TT8045EN
September, 2017
Page 1 of 5

SUBJECT: Incorrect Calibration Setting for Primary Mode: Gears in Freightliner Custom Chassis Corporation (FCCC) Motorhome Chassis

MODELS AFFECTED: FCCC Motorhome Chassis MC, XBS, XCR, and XCS with 2500MH Series Transmission

Figure 1. Example of the Incorrect Setting Prior to Reflashing

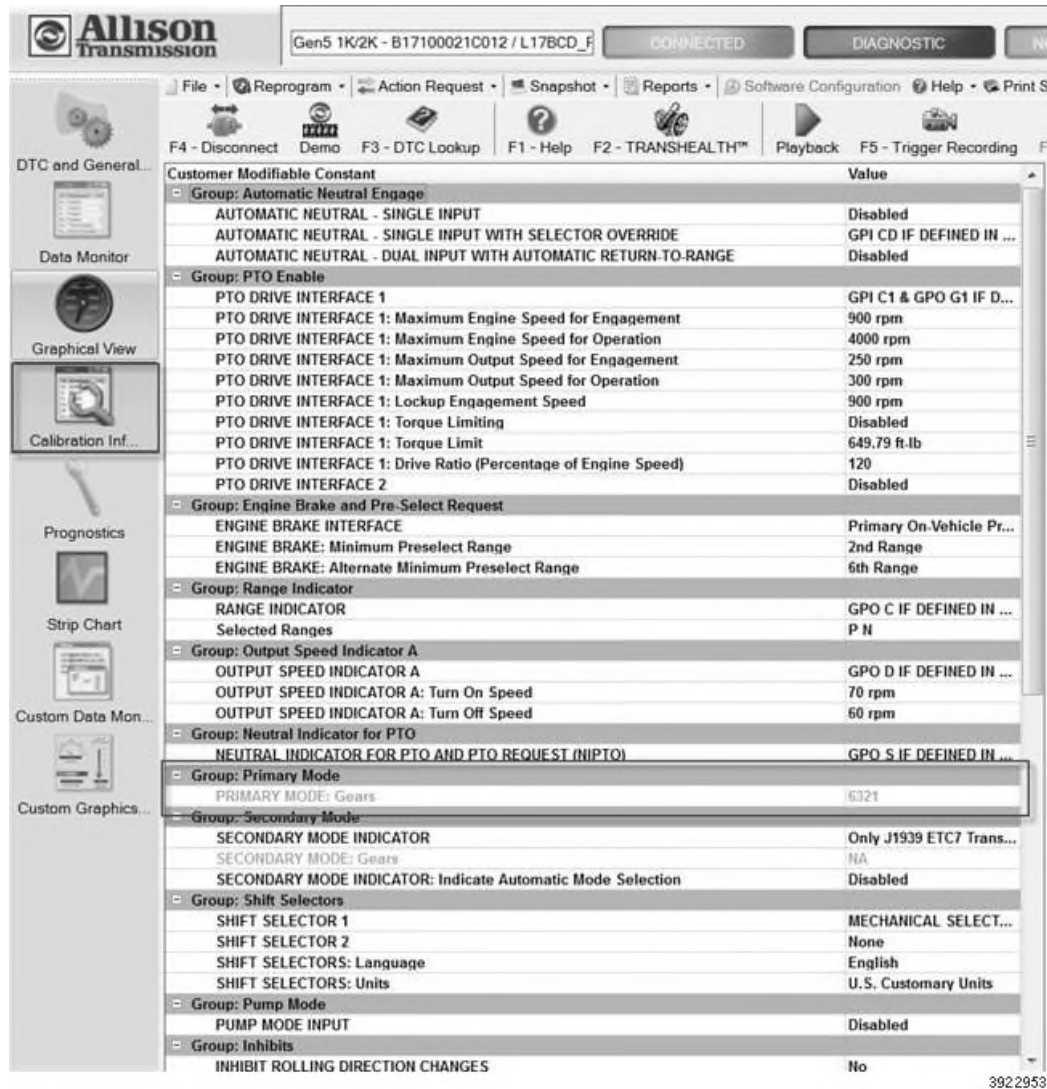
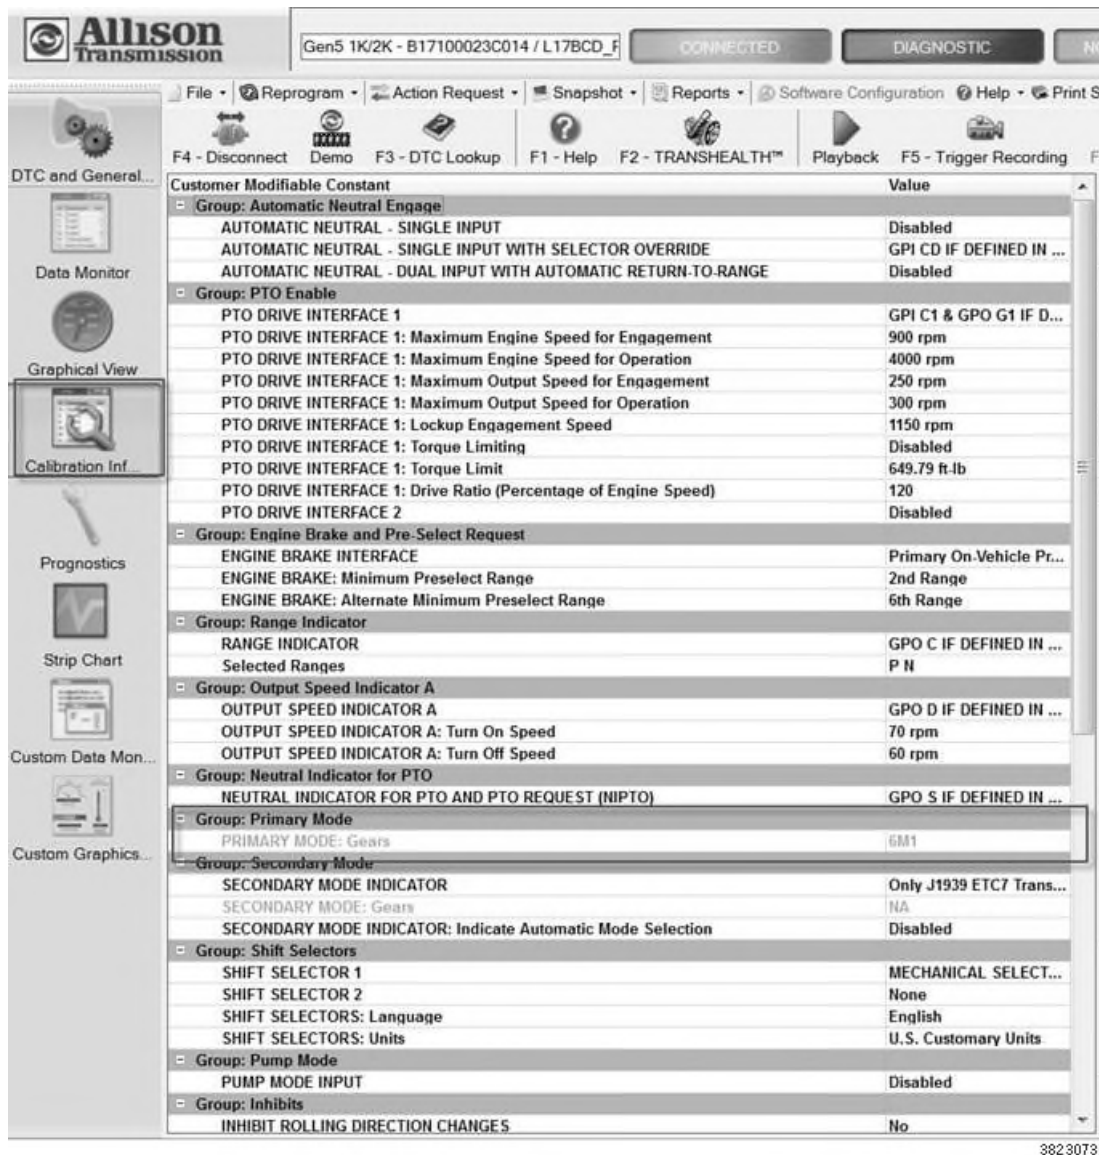
The Primary Mode: Gear calibration setting was incorrectly set to 6321 instead of the proper setting of 6M1 for 6-speed units in the affected population. 5-speed units were incorrectly set to 5321 instead of the correct setting of 5M1 for units in the affected population. This correction will allow preselect downshift, which allow an increase in engine speed, thus increasing the amount of engine braking.

Connect to the TCM using Allison DOC® to verify that the calibration parameters are set to correct settings. Once connected to the TCM, select the Calibration Information icon. Look at Group: Primary Mode to verify the correct setting. Figure 1 is an example of the incorrect setting prior to reflashing. Notice the Value for Primary Mode: Gears is set to 6321. The value may be 5321 on some of these motorhomes.

Figure 2 is an example of the correct setting after reflashing. Notice the Value for Primary Mode: Gears is set to 6M1. The value may be 5M1 on some of these motorhomes.

NOTE: 6-speed transmission will use 6M1 and 5-speed transmissions will use 5M1.
